Status of IEEE P802.3ar/D1.3

7 July 2006

Granularity of ipgStretch (2)

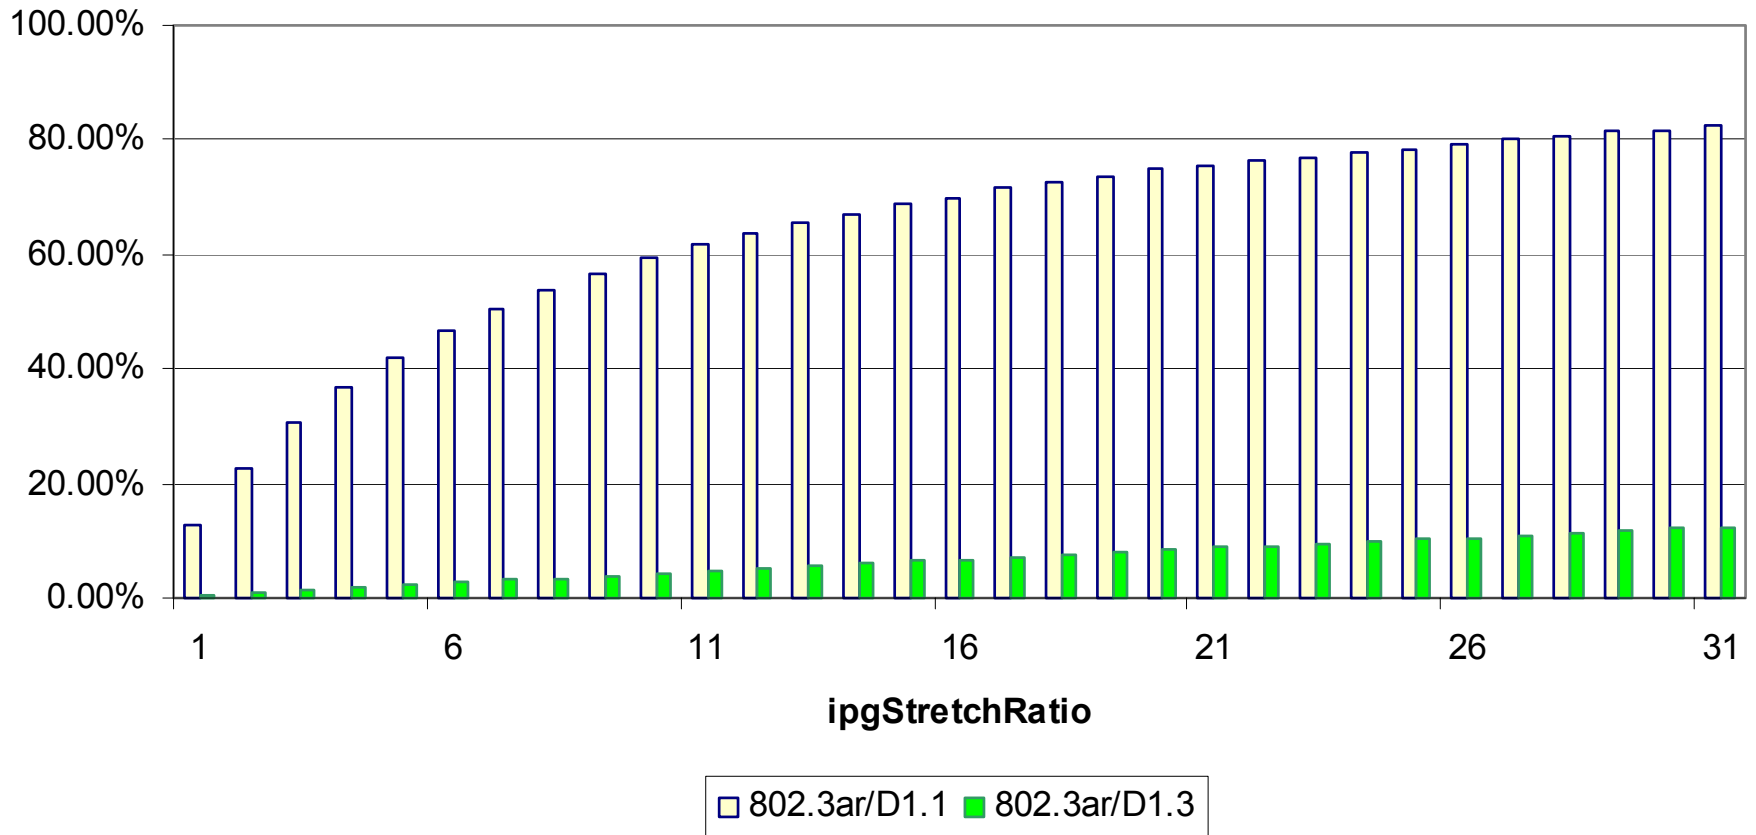
- **Granularity of ifsStretch**
 - D1.1/ifsStretch does not provide a useful means for limiting the effective data rate to a small (<70%) fraction of the nominal rate.
- **D1.1 vs. PAR**
 - The PAR title should be changed to reflect this reality, to avoid confusion in the marketplace
- **D1.1 vs. Objectives**
 - Does not address 2 of the 4 objectives and poorly addresses the rate limiting objective
- **D1.1 vs. 5 Criteria**
 - Reflects initial broader scope of congestion management, of which rate limiting was one component
- **D1.1 vs. 802.3 operating rules**
 - Incomplete due to missing editing instructions for Annex 4A and absence of Annexes 30A and 30B

- **Granularity of ifsStretch** ← **FIXED**
 - D1.1/ifsStretch does not provide a useful means for limiting the effective data rate to a small (<70%) fraction of the nominal rate.
- **D1.1 vs. PAR** ← **REVISED**
 - The PAR title should be changed to reflect this reality, to avoid confusion in the marketplace
- **D1.1 vs. Objectives** ← **REVISED**
 - Does not address 2 of the 4 objectives and poorly addresses the rate limiting objective
- **D1.1 vs. 5 Criteria** ← **NARROWED**
 - Reflects initial broader scope of congestion management, of which rate limiting was one component
- **D1.1 vs. 802.3 operating rules** ← **COMPLETE**
 - Incomplete due to missing editing instructions for Annex 4A and absence of Annexes 30A and 30B
